**CITY OF PORTLAND**

This is to certify that CHESTNUT STREET UNITED METHODIST CHURCH/M & LI  
has permission to Change of use from Business to assembly business, interior renovations, handicap ramp, new walls entry door,  
Kitchen & ADA bathroom

Re: Renovations to 185 High Street  
Chestnut Street Methodist Church  
Portland, Maine

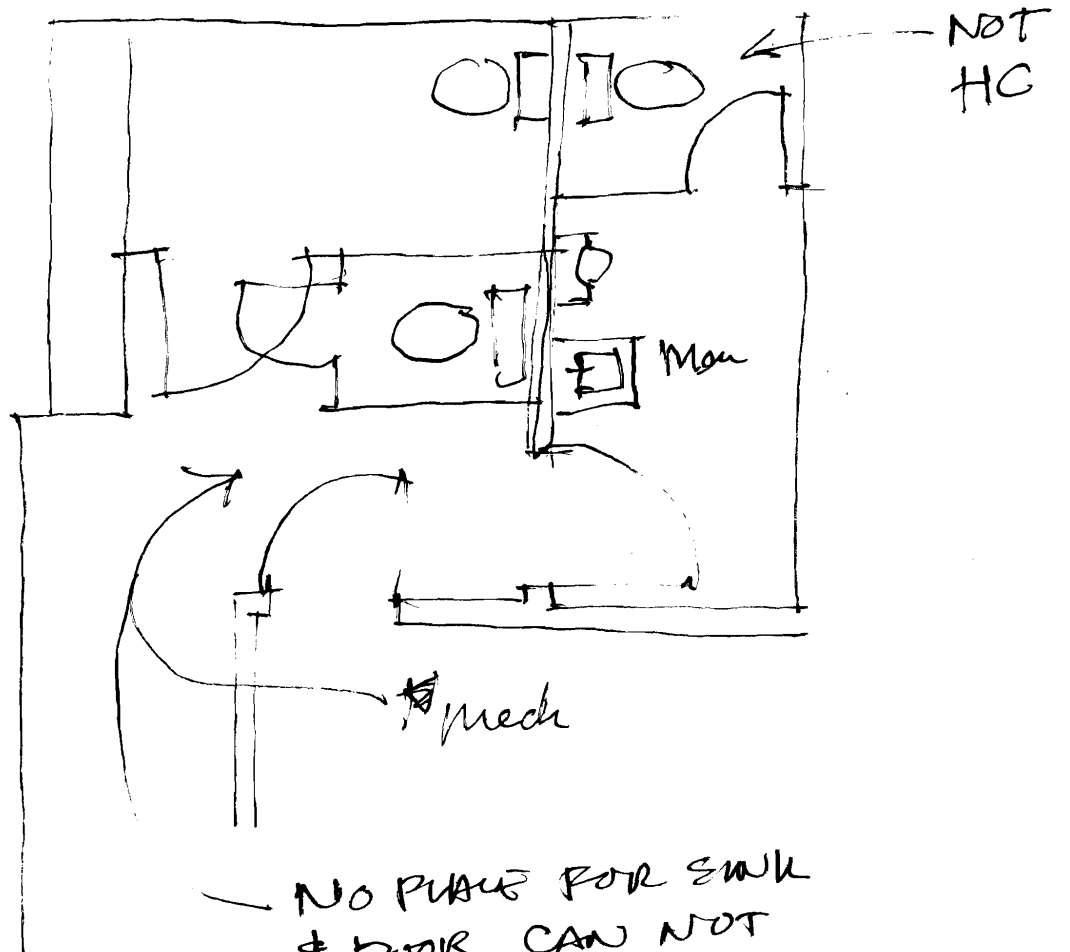
Pursuant to our telephone conversation yesterday (Jan. 12<sup>th</sup>), I would like to offer the following for you to consider in reviewing the plumbing fixture counts proposed on the submitted plans to be constructed as detailed:

1. For Worshipping Places, the Maine State Internal Plumbing Code stipulates combined toilet/urinal counts of 1 fixture per 75 occupants per sex, or 2 per 150 occupants total;

2. At a maximum of Occupant Load of 82, the proposed worship place will have about half as many occupants as the Plumbing Code contemplates as the "minimum";

3. Given the above, it makes sense that even with 2 total water closets as proposed, the facility will be supplied with almost twice the stipulated capacity to serve the occupants;

4. Due to the occupancy type, the Plumbing Code also suggests a urinal in the men's room, which in the case of this small facility, would double the required base capacity which, given the small size of this facility, would in turn translate into almost four-times real need for men (at 1:75, 41 men = .55 fixtures needed);

5. The owner has agreed that the fixture count shown on the plans will more than satisfy their needs;
6. Due to the extensive space requirements, it is physically impractical to provide (2) handicapped 2-fixture restrooms with lavatories in the space allocated without substantially encroaching on large areas of the remaining facility, in turn making the cost of the improvements unmanageable and substantially reducing the usefulness of the remaining space.

Therefore, given the logical analysis of the existing conditions, we respectfully submit that we construct the toilet facilities as drawn.

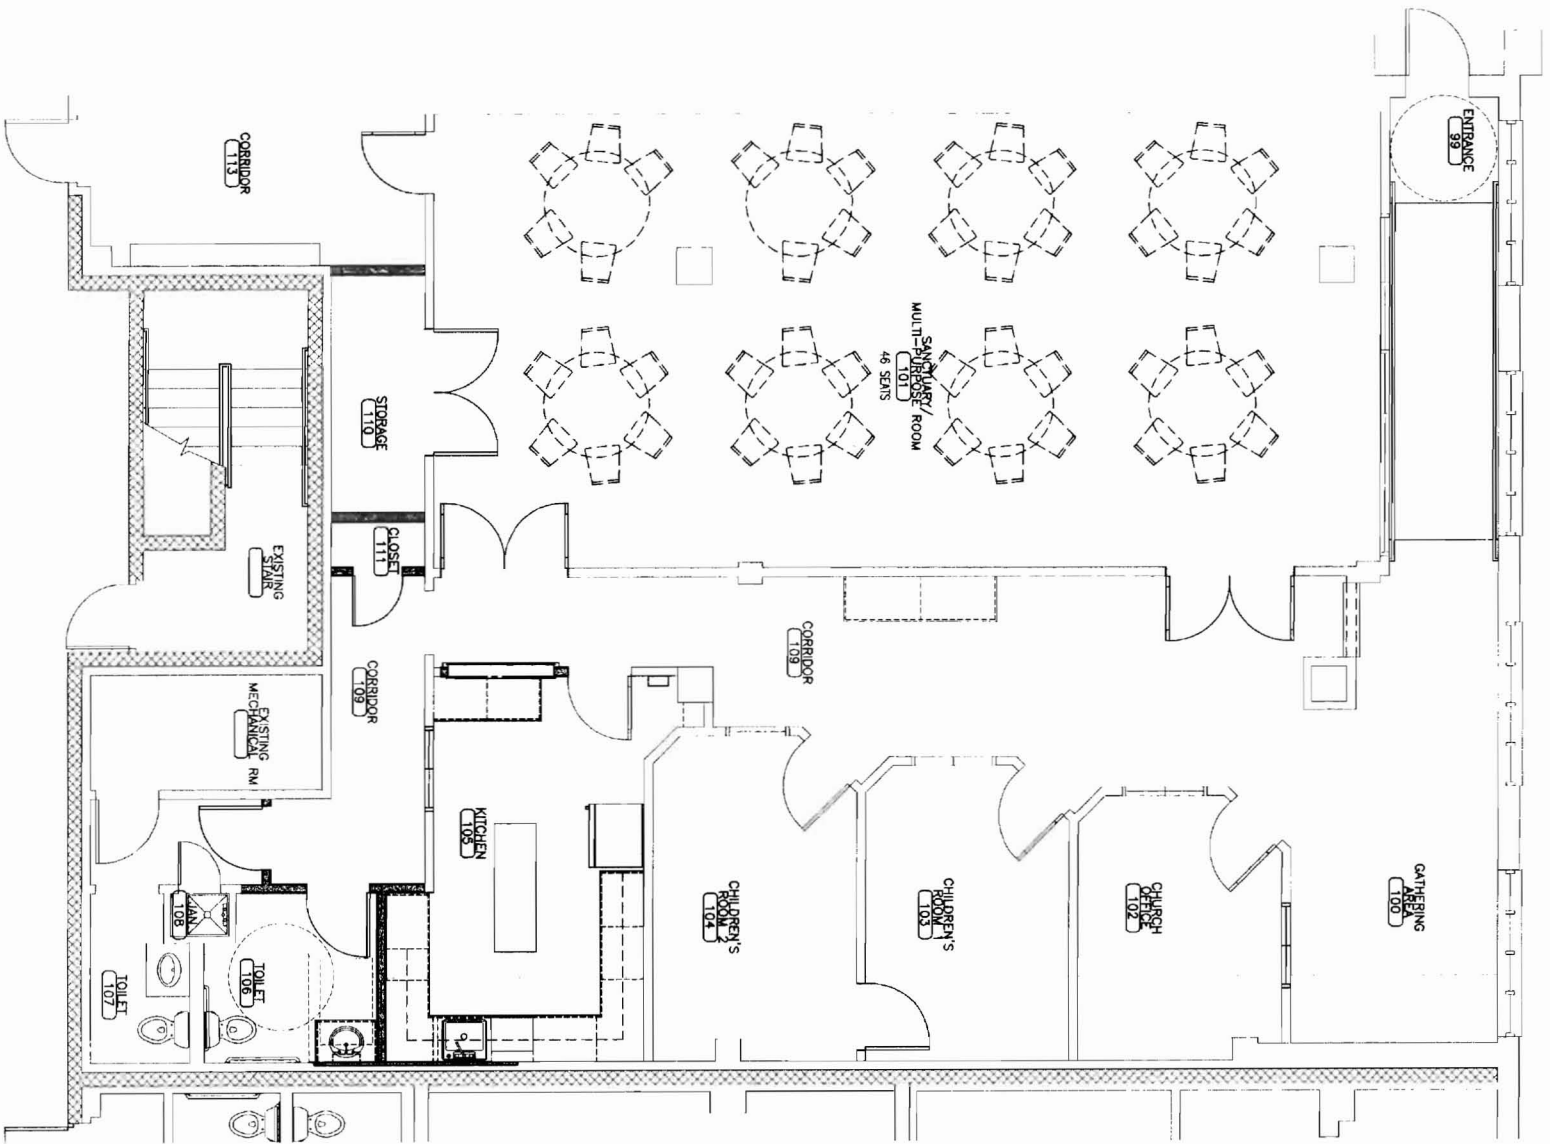
NO PLACE FOR SWK  
 & DOOR. CAN NOT  
 ENTER MEN'S ROOM  
 W/O GOING THRU  
 WOMEN'S ROOM
